COMMAND MODULE 4.0

Command Module Safety Box Input Harness

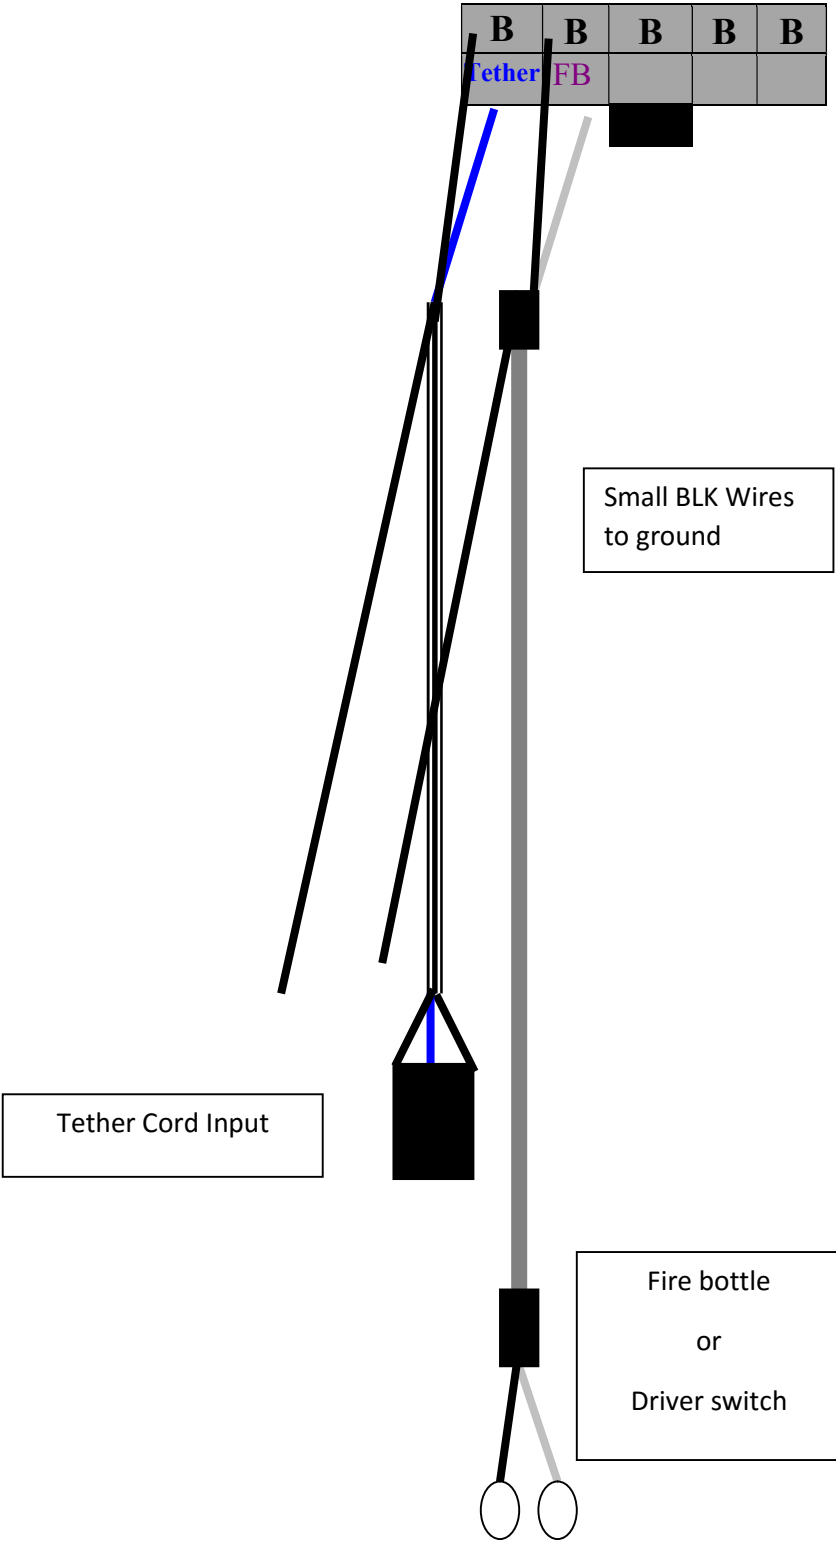
- Make all new files from carfile.ema out of this box (do not use old files)
- Rev-Limiter now built-in. 2 step rev-limit also.
- Display turns red when safety box is tripped.
- File transfer menu has changed.
- Air regulators and Timing Controller have curve shift capabilities.
- Updated software available on www.electrimotion.com.
- Racepak voltage output levels have changed from SB001a

Standby Analog output = 0.125v

Fire Bottle/Driver Button Analog out = +0.125v change

Tether Analog output = +0.25v change

RF Analog output = +0.75v change
